A quick check of GAS-II / cable / ADC125 linearity

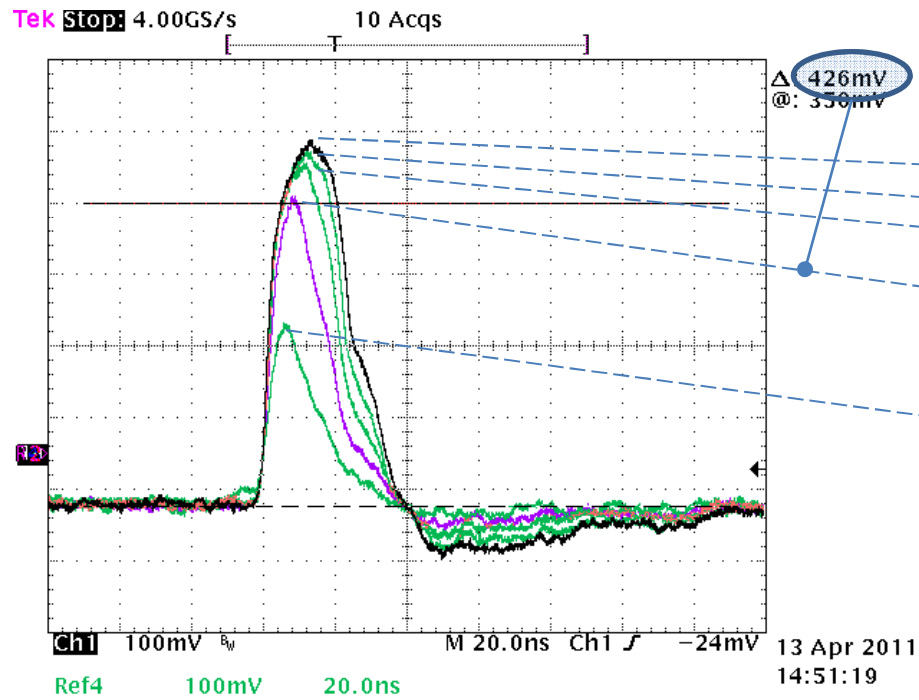
→ It certainly looks like we **should increase the gain of the ADC125** by about a factor of 2...

(Or better from a signal/noise standpoint, improve the linearity and output range of the ASIC, but too late for this now?)

Caveat: This measurement is on a preamp board that I have. It is set for cathodes, and quite different gain setting than the CDC is using. The measurement should be repeated on a board setup for CDC usage.

Fernando: "The preamp you have is set for a gain of 3.2 mV/fC and a dynamic range of 110 fC (@ 5% linearity), quite different from the CDC. This is the fifth row in the Table 2 of GlueX-doc-1364 (the CDC is set as per the second row - 0.57 mV/fC, DR=380 fC)."
